APPENDIX A

MARKED-UP TECHNICAL SPECIFICATION PAGES

APPENDIX B

REVISED TECHNICAL SPECIFICATIONS PAGES

FIGURE 3.3.1.
THERMAL POWER LIMITATIONS DURING OPERATION WITH LESS THAN
TWO REACTOR COOLANT SYSTEM RECIRCULATION LOOPS IN OPERATION

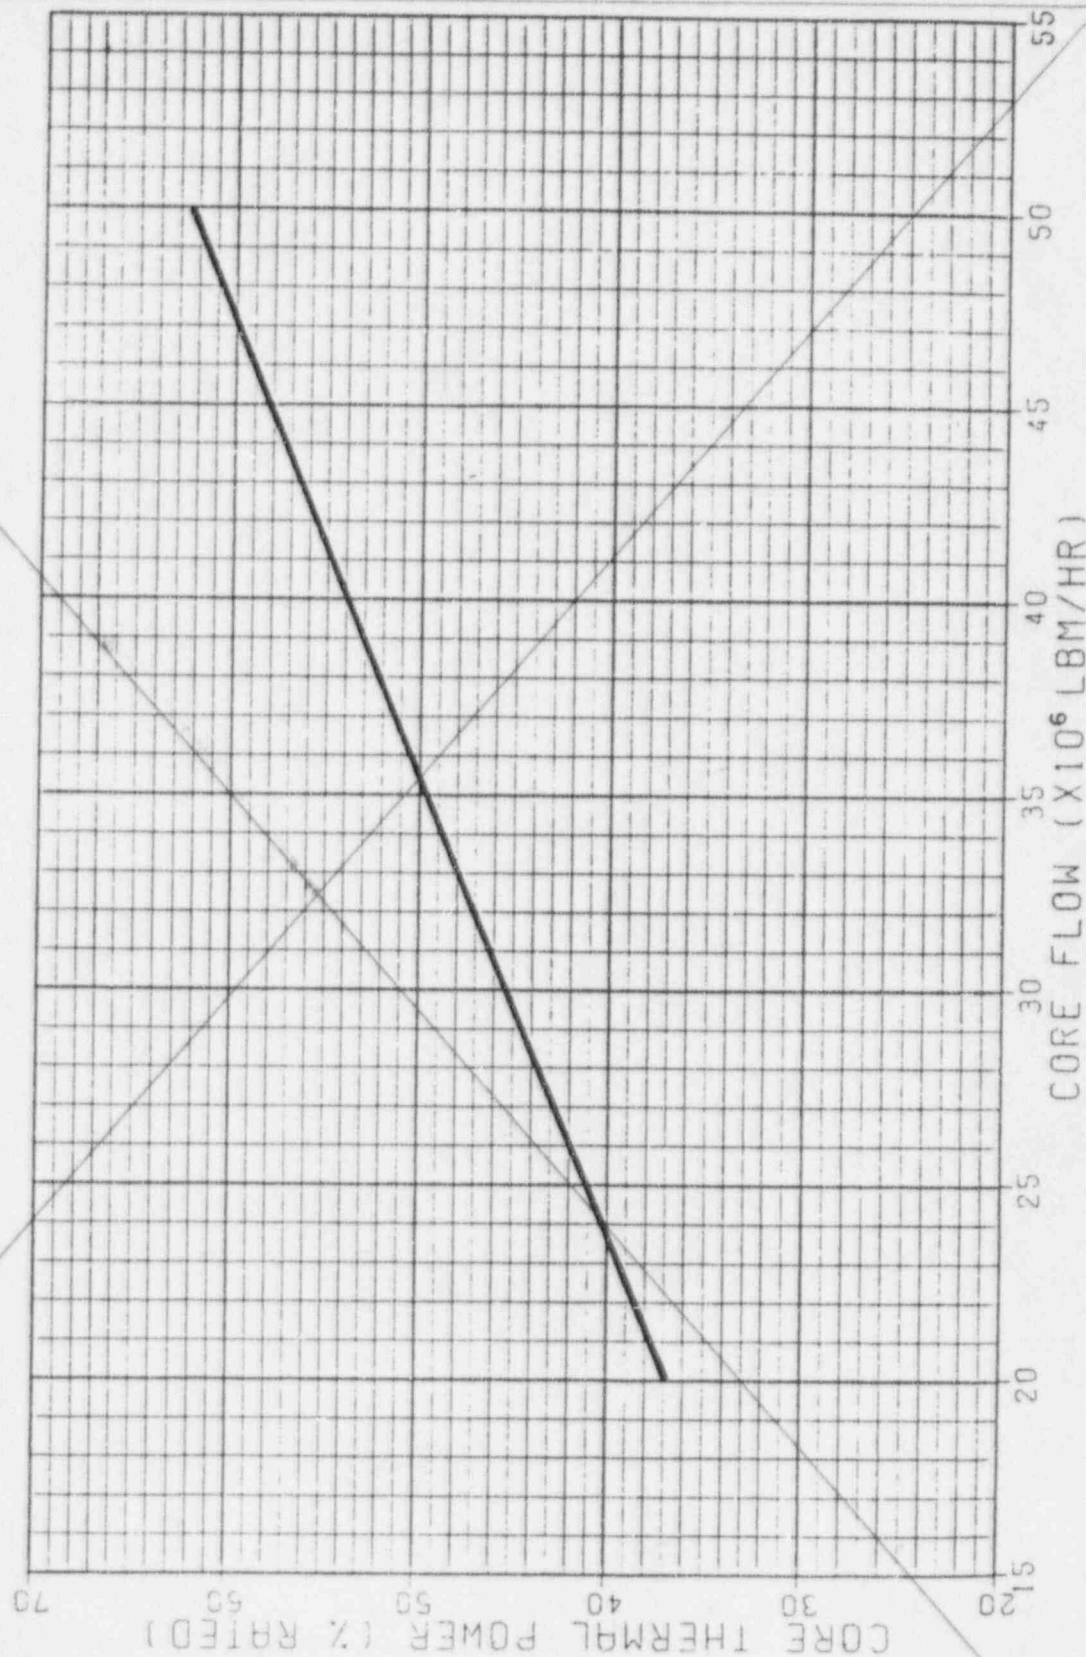
2. With two recirculation pumps in operation and with core thermal power greater than the limit specified in Figure 3.3.1 and total core flow less than 45% of rated, the APRM and LPRM* neutron flux noise levels shall be determined within 2 hours, and:

1. With two recirculation pumps in operation and with core thermal power greater than the limit specified in Figure 3.3.1 and total core flow less than 45% of rated, establish baseline APRM and LPRM* neutron flux noise levels within 2 hours, provided that baseline values have not been previously established since the last core refueling.

2. a) Prior to operation with one recirculation pump not in operation and core thermal power greater than the limit specified in Figure 3.3.1 establish baseline APRM and LPRM* neutron flux noise levels, provided that baseline values have not been previously established since the last core refueling. Baseline values shall be established with one recirculation pump not in operation and core thermal power less than or equal to the limit specified in Figure 3.3.1.

- a. with one recirculation pump not in operation and core thermal power greater than the limit specified in Figure 3.3.1, core flow must be greater than or equal to 45% of rated, and

- (i) the Surveillance Requirements of 4.3.F.2.a have not been satisfied, immediately initiate action to reduce core thermal power to less than or equal to the limit specified in Figure 3.3.1 within 4 hours, or
